### 龍門計劃國外製造機械、儀電設備製程中品質查驗

服務機關：台灣電力公司核能安全處

1. 龍門計畫 MS026 「Large Rubber Expansion Joints」採購案，採購合約為 8749011M02600，採購規範為 Specification No. 874-MS-026 Amendment 3, Rev. 0，Quality Class 為 R。本採購

**台灣電力公司 龍門施工處**  
**TPC LUNG MEN CONSTRUCTION OFFICE**  
**不符合報告**  
**NONCONFORMANCE REPORT (NCR) NCR-TGD-451**

**Attachment 3**

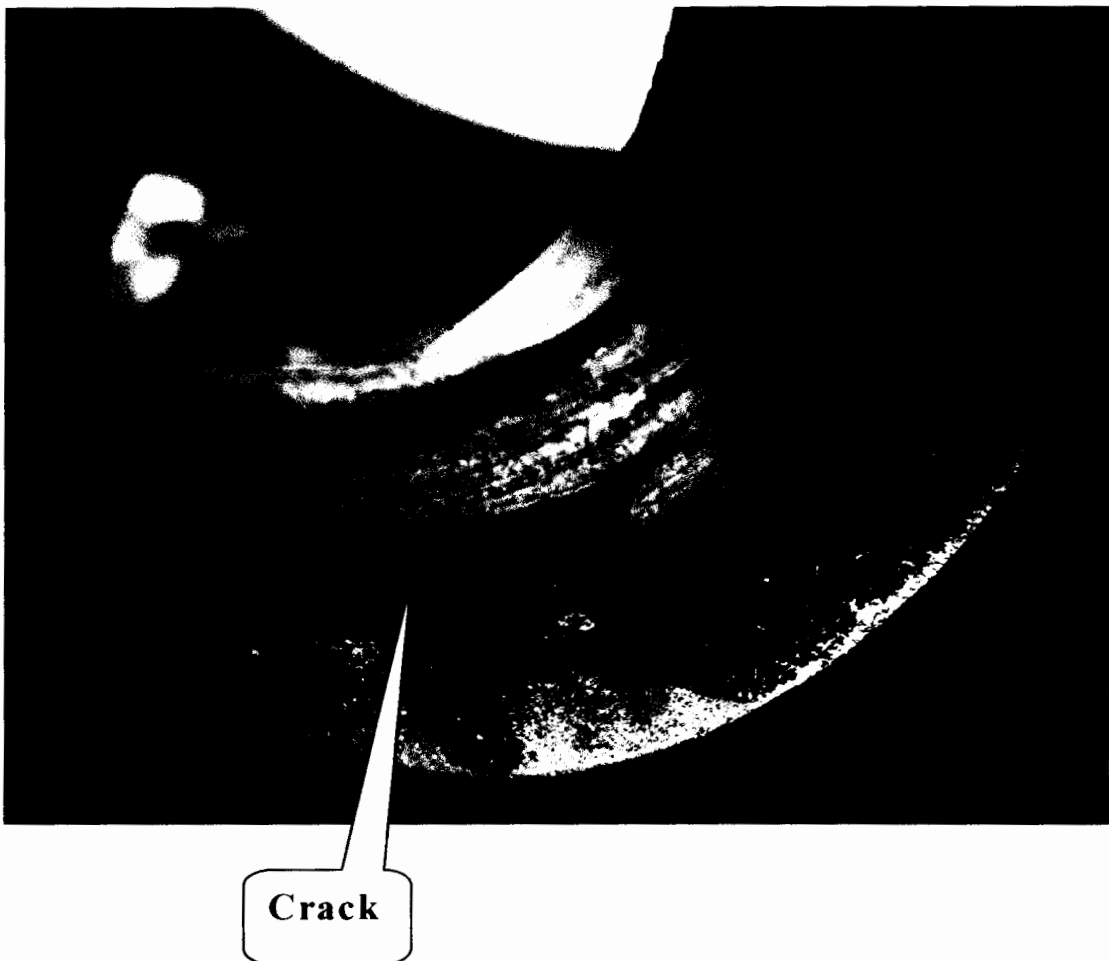
**Crack on flange surface near the tube.**

**Crack on the flange rim.**

**Crack on flange surface near the tube.**

**Damage/ Cracks on flange surface.**

**Cracks in bolt hole.**

**Crack on tube near the flange surface.**

**Damage on tube surface.**

**Rust on R/Ring./ Poor bond and separation between R/Ring & Body.**

**.Poor bond between R/Ring & Body.**

**Crack / Poor bond between R/Ring & Body.**

**Rough and peeling on flange surface.**

**Crack in bolthole. It shall be sealed to completely cover the carcass fabric.**

**Damage on flange rim.**

**Peeling on flange surface near the tube.**

Figure 1.88 — Checking angular alignment

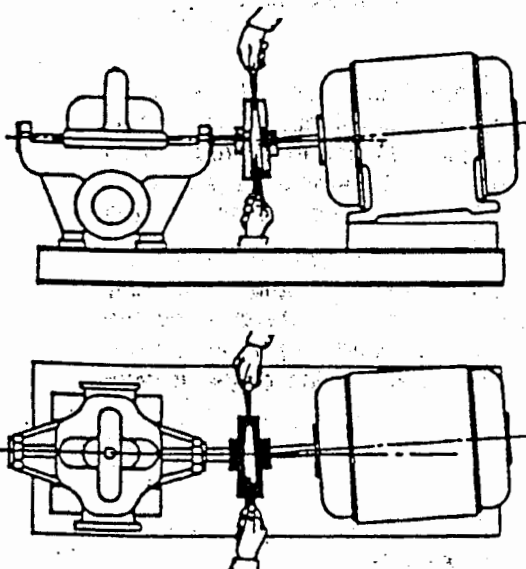
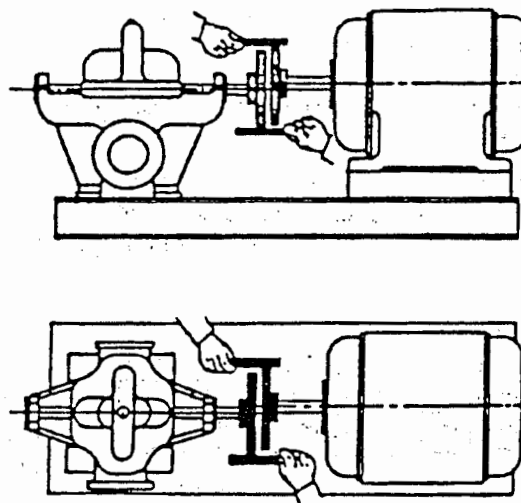
3. As to shown in the Reference 1 Attachment 1, the face to face lengths are not same among No.1 thru No. 6, so each joint's two flanges are not in parallel before installation. Do we need to check angular alignment or parallel alignment (referring to Fig. 1.88 & 1.89, Enclosure 2 for reference) in the installation between the joint's flange and pipe flange? If the answer is "Yes", please tell us the allowable maximum values accordingly.
